TO: ALL ROOTES DEALERS
 MODEL: SUNBEAM IMP
 SUBJECT: SHOCK ABSORBER NOISE.

REAR SHOCK ABSORBERS

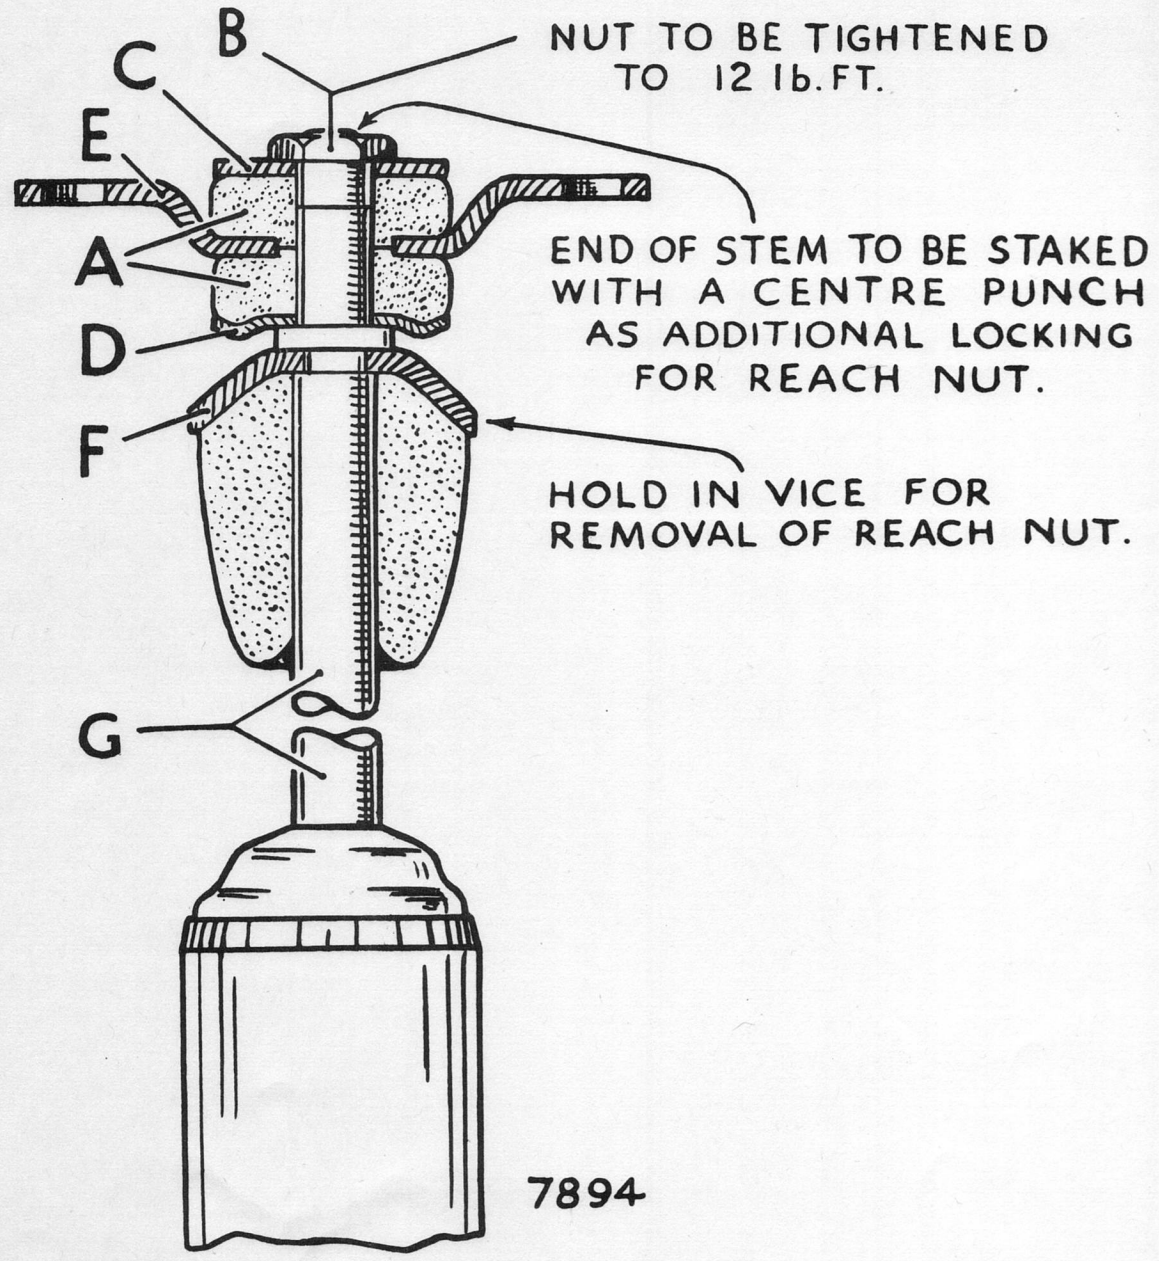
Where you are called upon to investigate complaints of rear shock absorber noise, the shock absorber mountings should be checked for tightness and if these are satisfactory, the following procedure should be carried out:-

1. Remove shock absorber from vehicle.
2. Grip the shock absorber lightly in a vice by the bump rubber location disc (F on illustration) taking care to ensure that the working surface of the piston rod (G) is not damaged.

3. Remove the reach nut (B) the upper retaining washer (C) the cushion rubbers (A) the upper mounting plate (E) and the lower retaining washer (D).
4. Clean the 3/8" UNF threads at the top of the piston rod using a 3/8" UNF die.

5. Fit replacement cushion rubbers (A) Part No. 7102949 and examine the upper mounting plate (E) Part No. 7102951; replace if necessary.
6. Refit new and old parts in the reverse order that they were removed, using a new reach nut (B) Part No. 7102945. Torque the reach nut to 12 lbs. ft. (1.6 Kg.m) and stake the nut, using a suitable centre punch.

7. Prime the shock absorber and refit to the vehicle as described in Workshop Manual 141, Section F. Page 13.

Cushion Rubbers (A on illustration) 7102949	2 off per shock absorber
Reach nut (B on illustration) 7102945	1 " " " "
Upper Retaining Washer (C on illustration) 7102950	1 " " " "
Lower Retaining Washer (D on illustration) 7102948	1 " " " "
Upper Mounting Plate (E on illustration) 7102951	1 " " " "
